-CITY OF PORT ARTHUR, TEXAS

ADDENDUM NO. THREE (3)

RFQ: STUDY, DESIGN AND DEVELOP A PROJECT TO CONVERT LANDFILL AND GAS INTO A LANDFILL GAS TO ENERGY PROJECT

BID # 23-047

ATTACHMENT 1

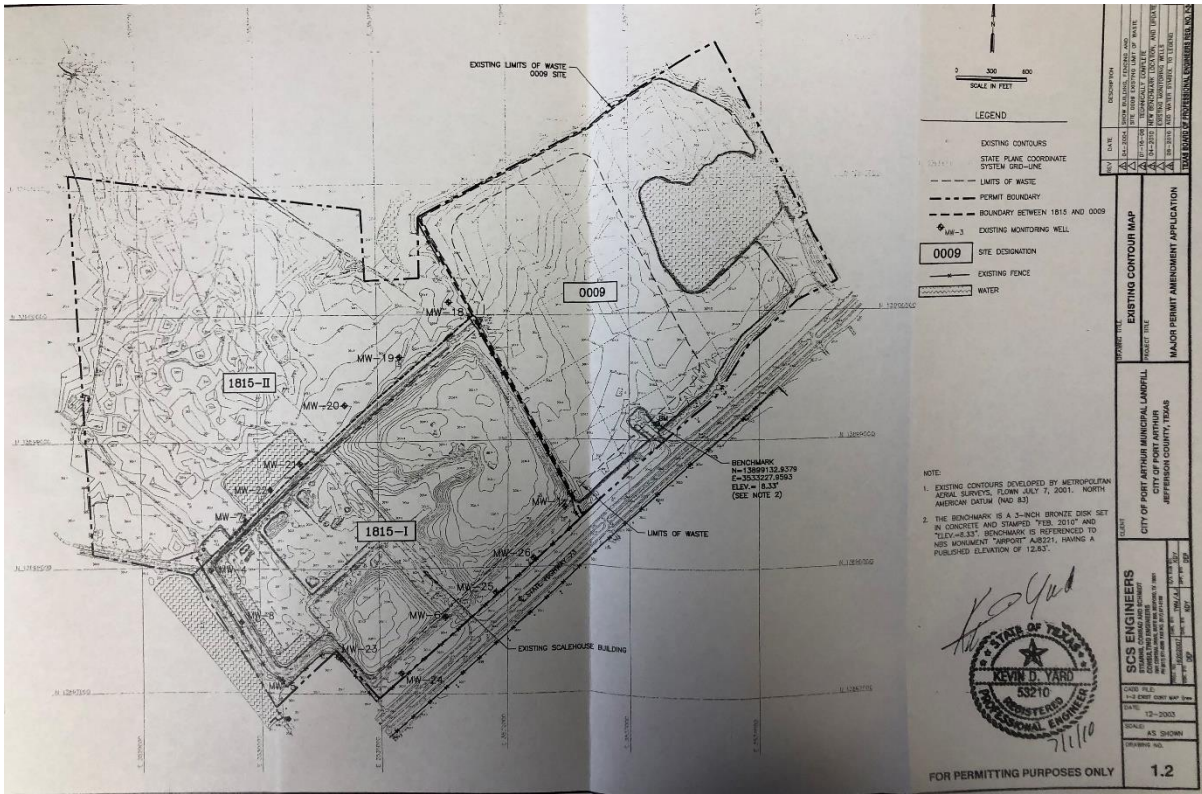
6. Please provide the design and as built drawings for the landfill and the landfill permitted area.

See Attachment 1 for Map.
